Subject: Limerick Generating Station, Units 1 and 2
Request for Information from the Auxiliary
Systems Branch

The attached documents are draft responses to Questions 410.100
thru 410.104.

QUESTION 410.100 (Section 9.1.2)

CONTROL STRUCTURE
HVAC SYSTEM
P&ID

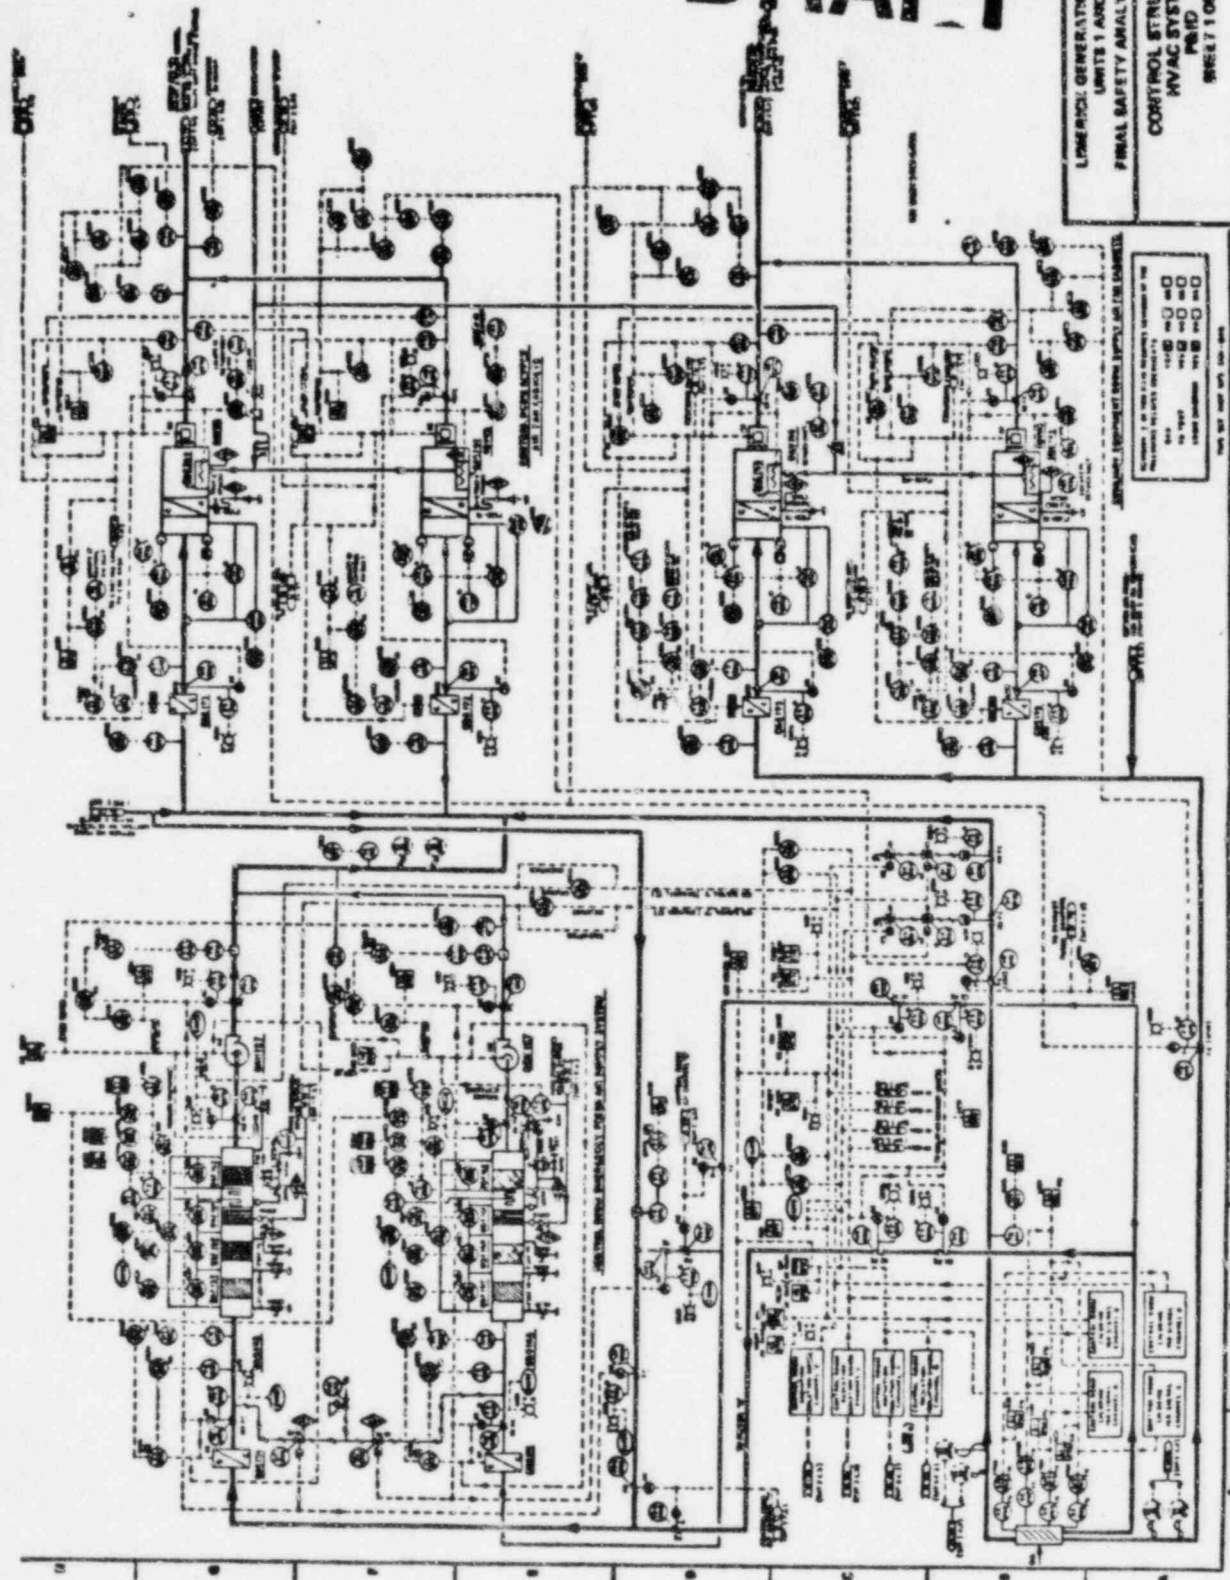
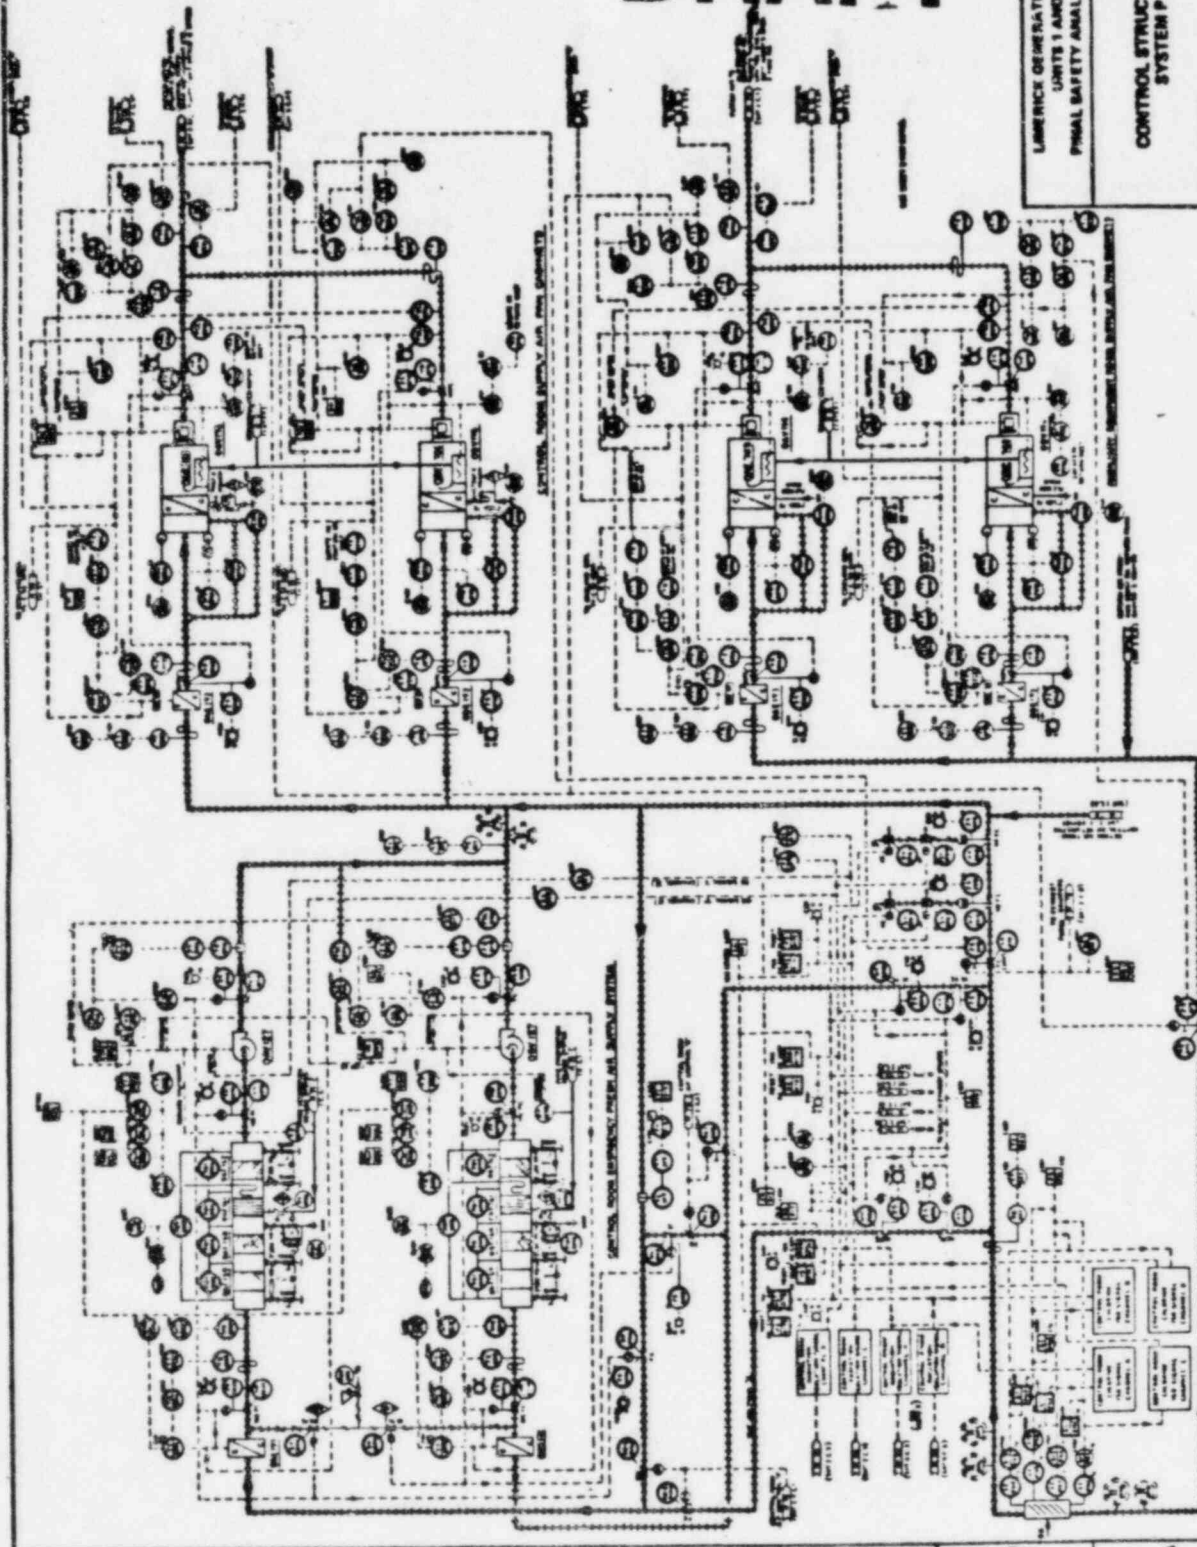
Revision 13 to the FSAR changed Figure 9.4-1 Sheet 1 to show that the control room air system is no longer seismic Category I. Provide justification for having nonseismic Category I air system for the control room.

put "railroad hatching" in
See previous figure
attached.

The change to Figure 9.4-1 Sheet 1 ^{was} ~~is~~ a drafting error. Figure 9.4-1 Sheet 1 has been revised to show that the control room air system is Seismic Category I.
